Addendum 15 — Regulation No. 16

Revision 8 — Amendment 3

Supplement 8 to the 06 series of amendments — Date of entry into force: 22 June 2017

Uniform provisions concerning the approval of:

"Figure 1

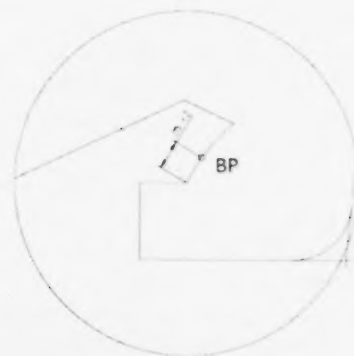
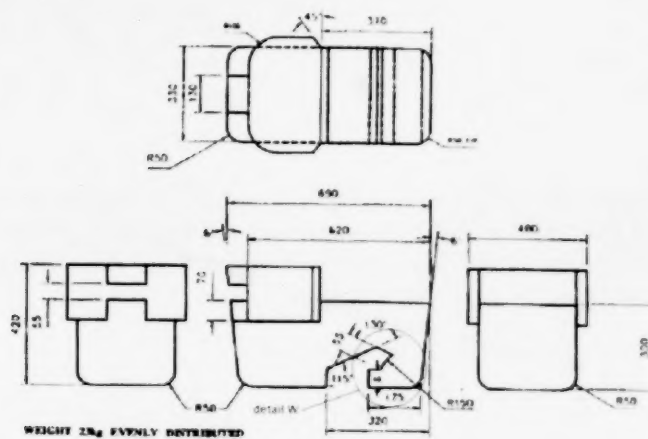
"3.2. The lap portion of the belt shall touch the fixture on both sides at the rear of the lap belt path (see Figure 3). The seat belt webbing shall always cover the points BP on the left and right ends of the curved edge; the exact position of point BP on the curved edge is indicated in detail W of Figure 1."

Figures 1 to 3, amend to read:
